FILE CSSTP-0006-00(049),
Cobb & Paulding Counties
SR 360 FM SR 176/COBB TO
SR 120/PAULDING
P.I. No. 0006049

SUBJECT **Request for VE Reversal**

RE: **VE Study Reversal**
CSSTP-0006-00(049), Cobb/Paulding Counties
PI No. 0006049
SR 360 From SR 176/New Macland Rd to SR 120/Paulding

PI No. 0006049
SR 360 from SR 120 to SR 176
Paulding and Cobb Counties
Request for VE reversal

ALTERNATIVE NO.
ROW - 3
STA. 60+00
SHEET 23 OF 32

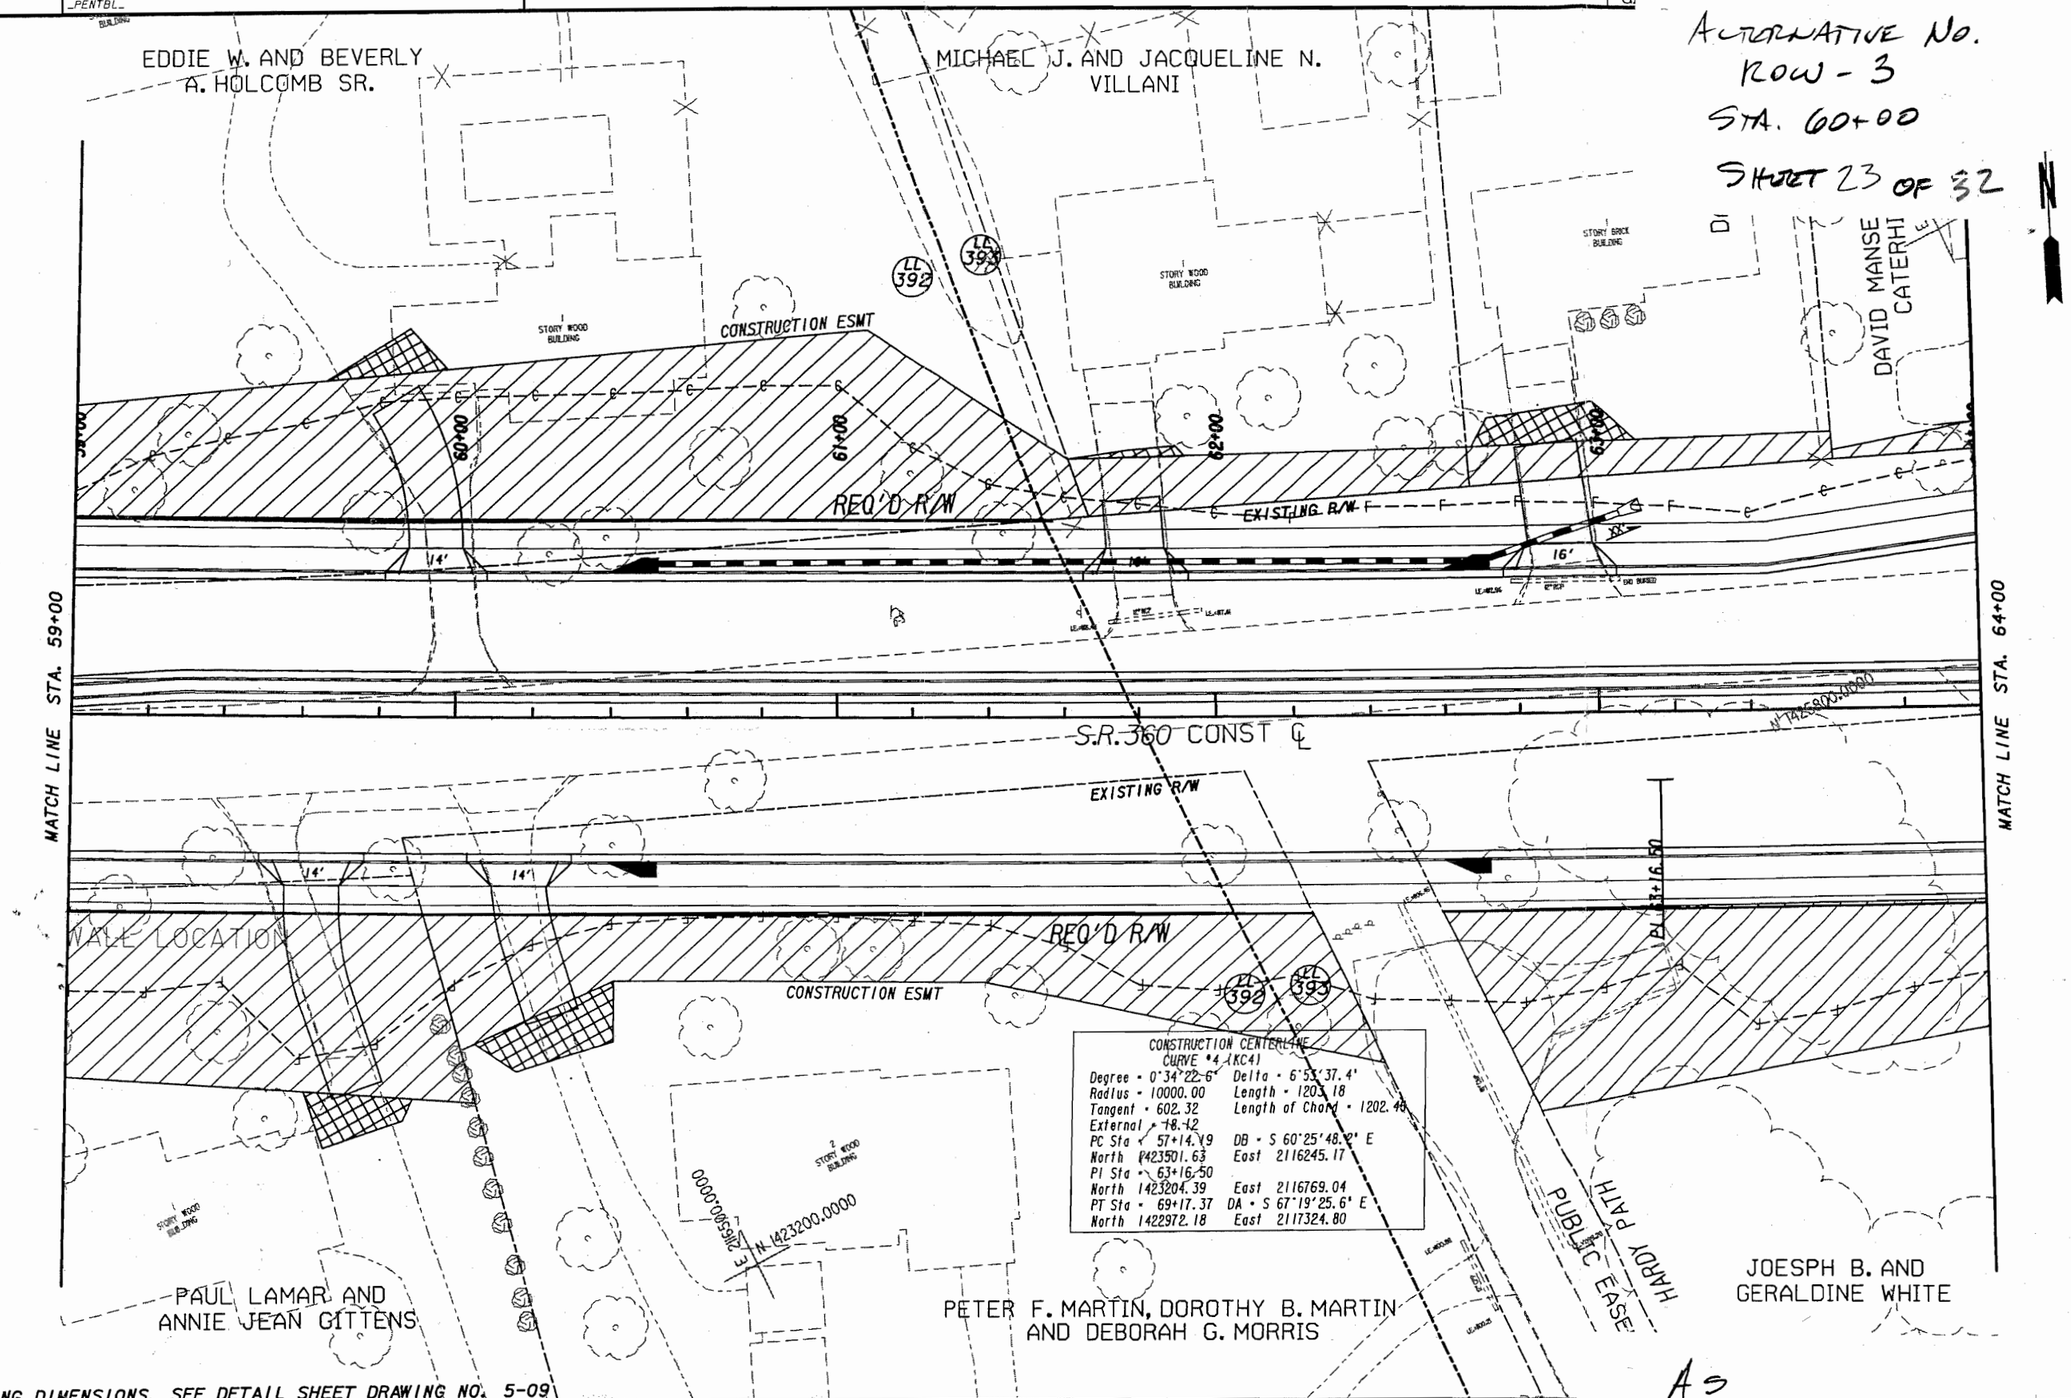
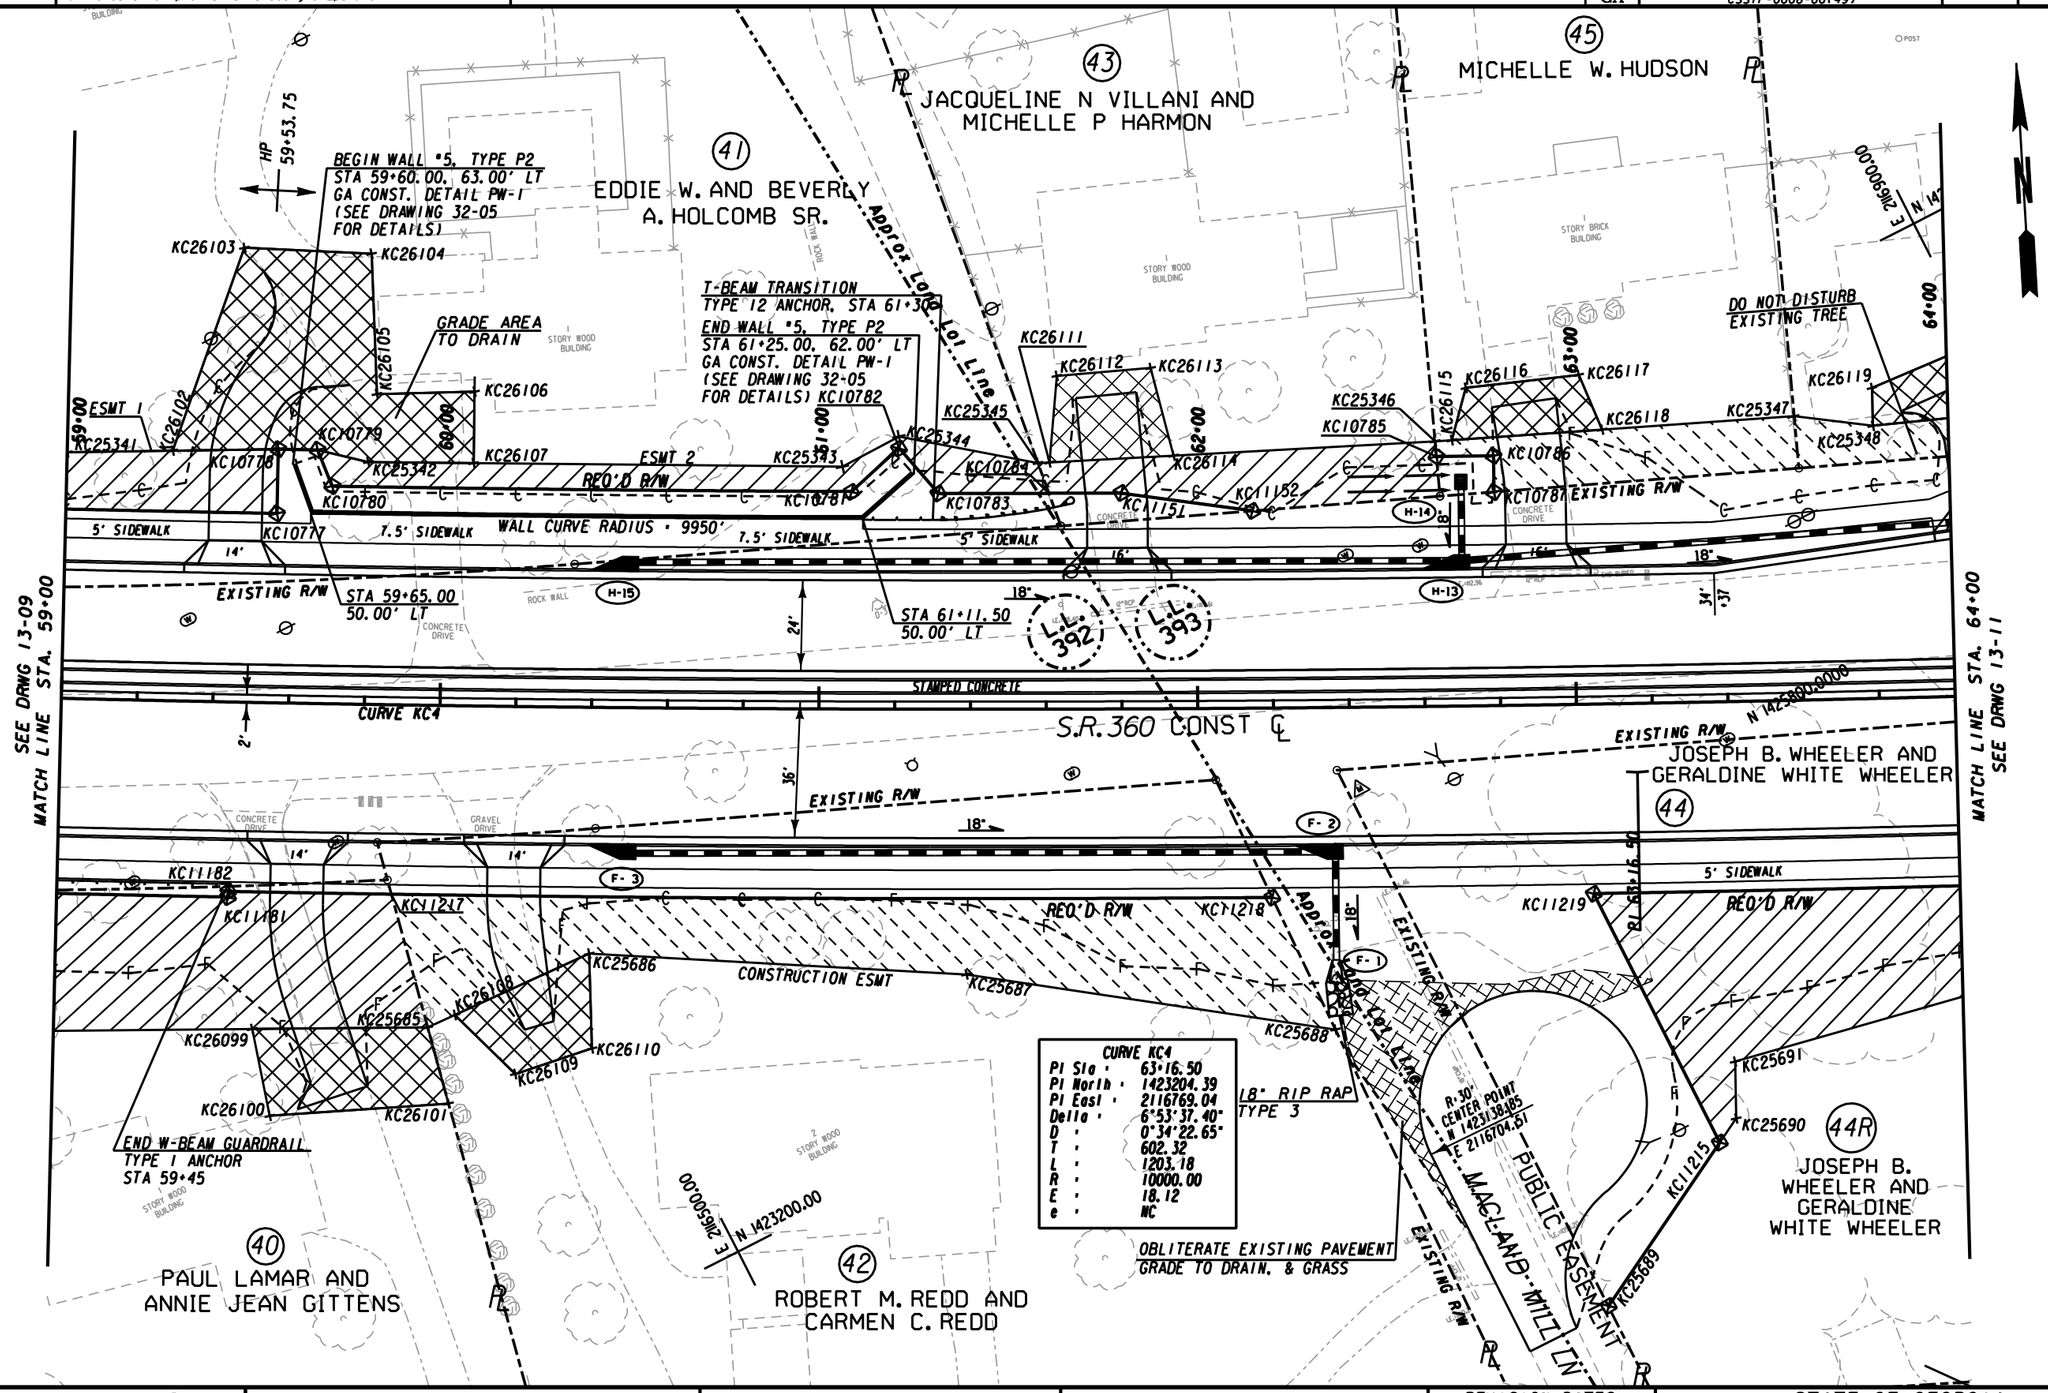
Since the VE study was completed, all four walls have been fully designed and incorporated into the plans. Subsequently, two of the walls have been re-analyzed and reviewed, and determined that it would be a reduction in project cost to remove the walls. (~sta 31+00 Lt Parcels 10/13, and ~sta 60+00 Lt Parcel 41 (Holcomb) This has been fully coordinated the District 7 RW Office and through the RW negotiation process. Costs have been confirmed accordingly.

It is recommended to remove walls:

- ~sta 31+00 Lt Parcels 10/13
- ~sta 60+00 Lt Parcel 41 (Holcomb)

Without wall			With wall		
Item	units	no of units	Cost/unit	Total	no of units	Cost/unit	Total
embankment (negligable)							
Retaining Wall (P2)	lf	0			178	$450	$80,100
T-beam Guardrail	lf	0		$0	18	$46	$828
type 12 anchor	ea	0		$0	1	$1,970	$1,970
E&C (10%)				$0			$8,290
RW cost	sq ft			$2,248	5498	$2.50	$13,745
Easement/Demo Cost	sq ft			$0	1376	$1.25	$1,720
Relocation	ls			**$92,235**	0		$0
TOTAL				$94,483			$106,653

difference = $12,170

ALTERNATIVE NO. ROW-3
STA. 31+00
SHEET 13 OF 32

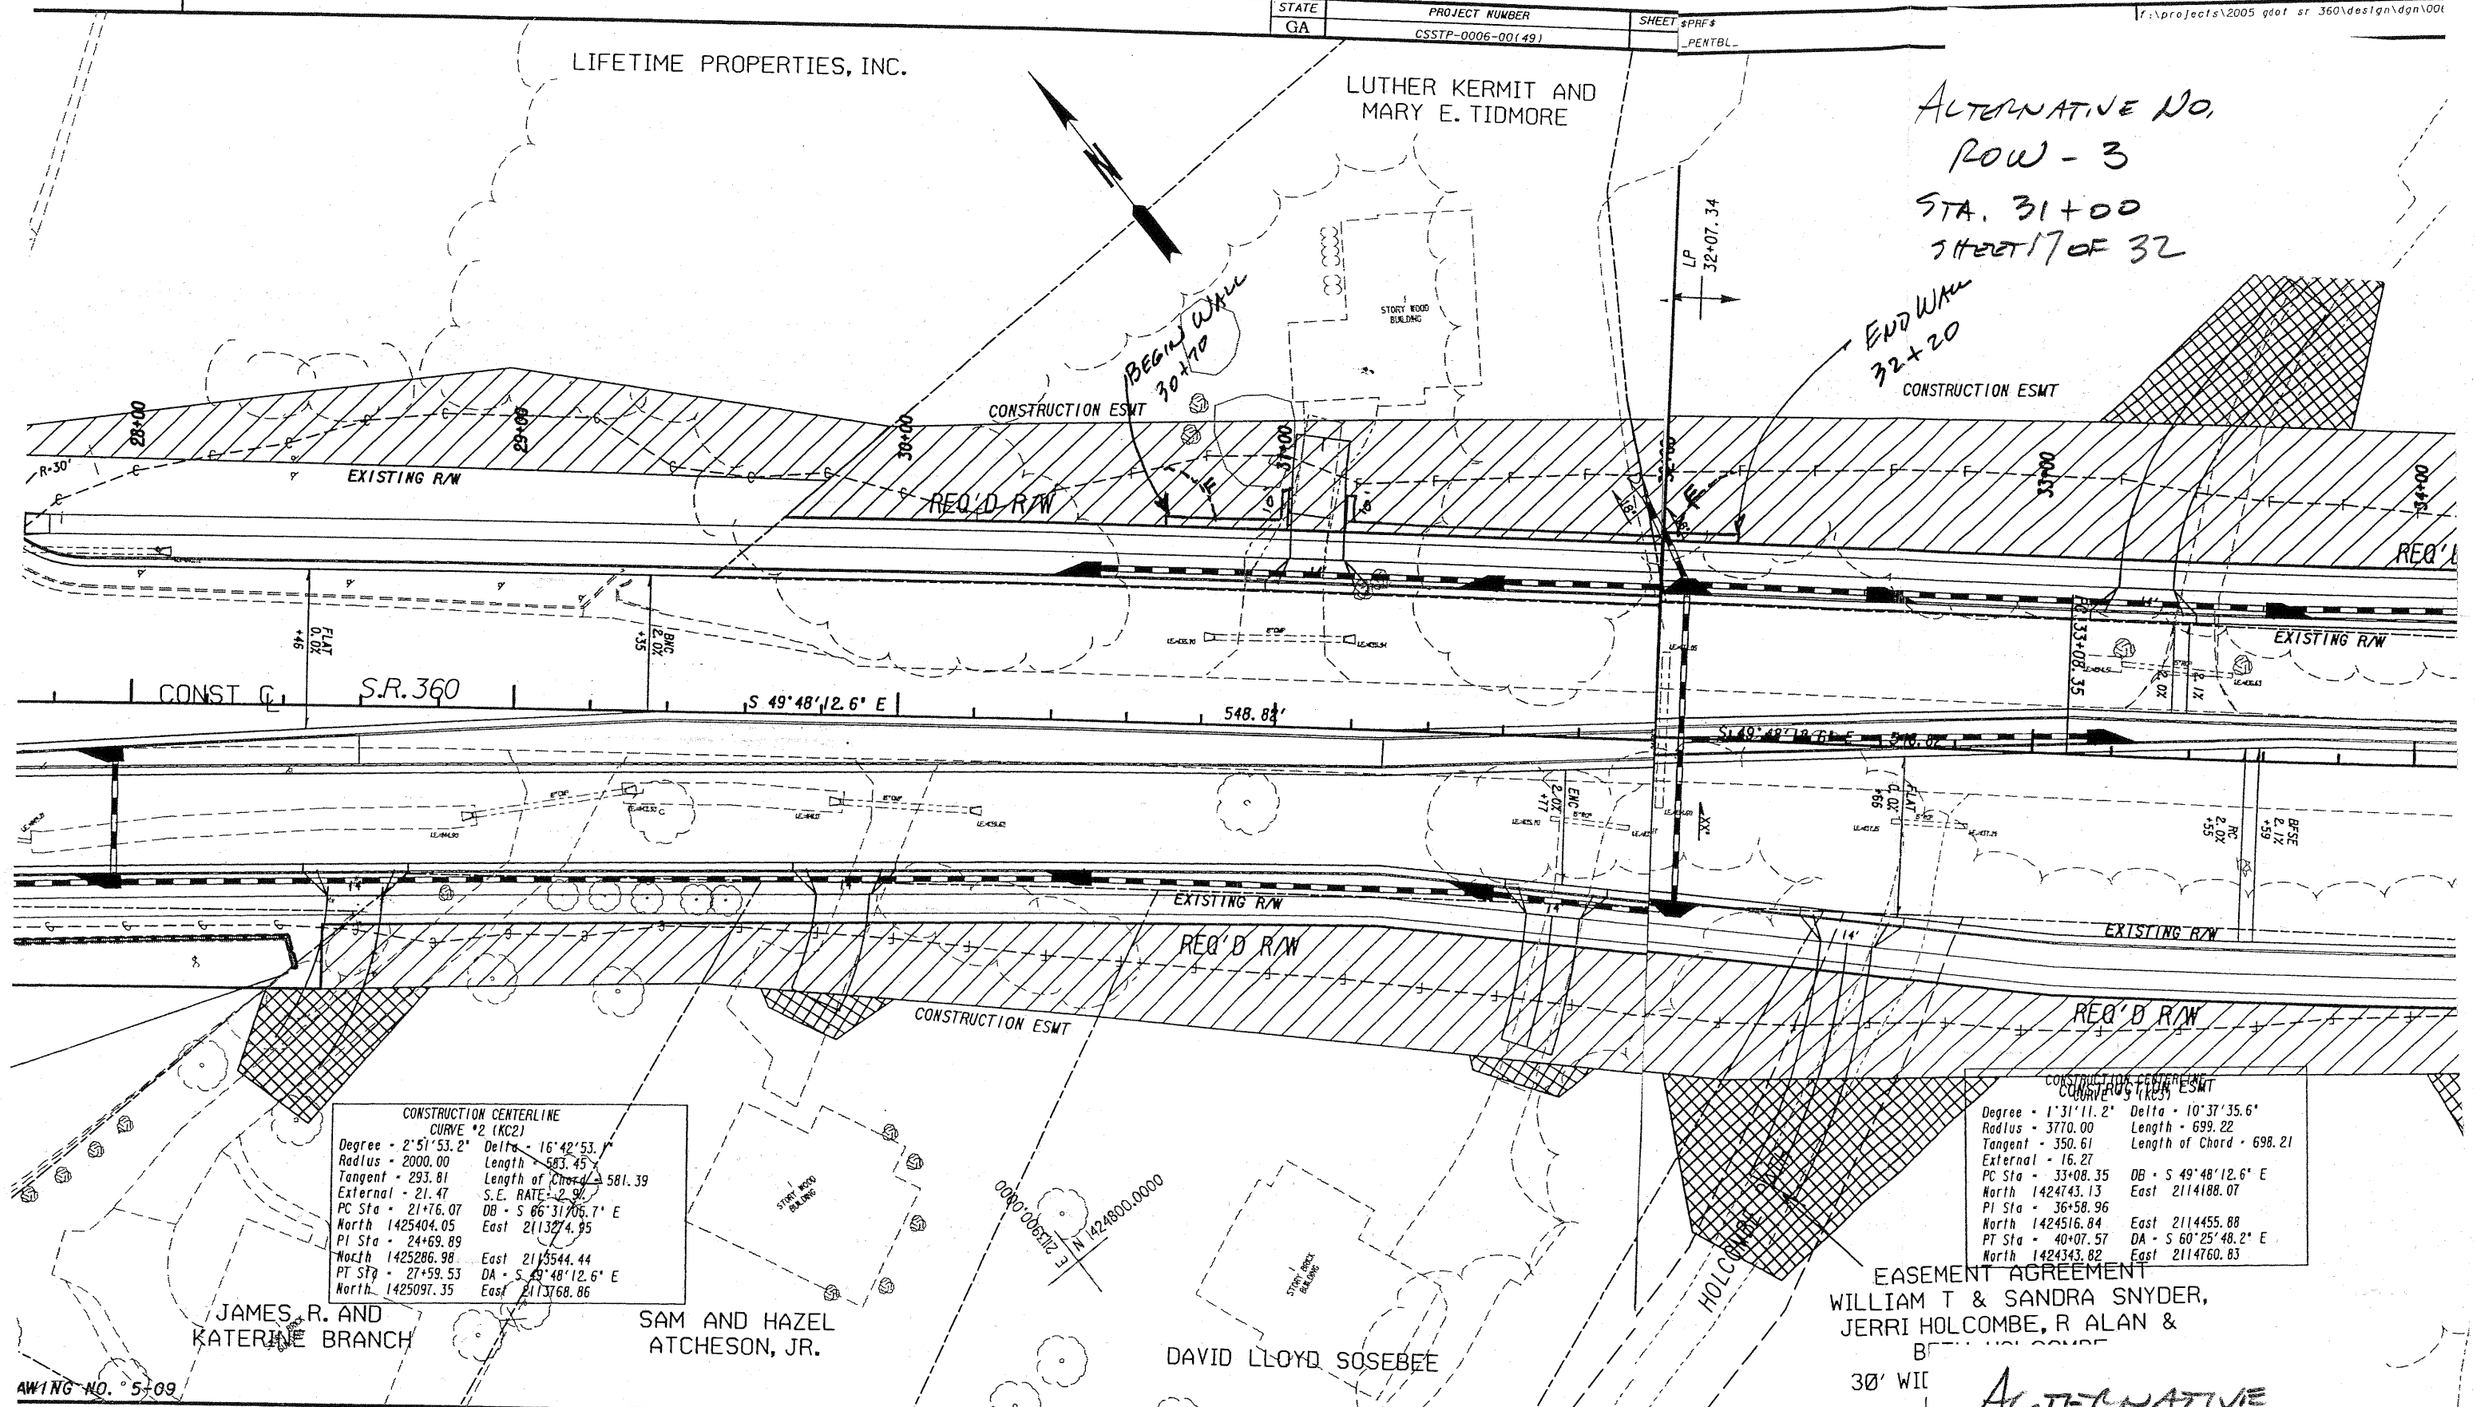
ROW-3	Use retaining walls to reduce right-of-way impacts	$90,179	Yes	This should be done.
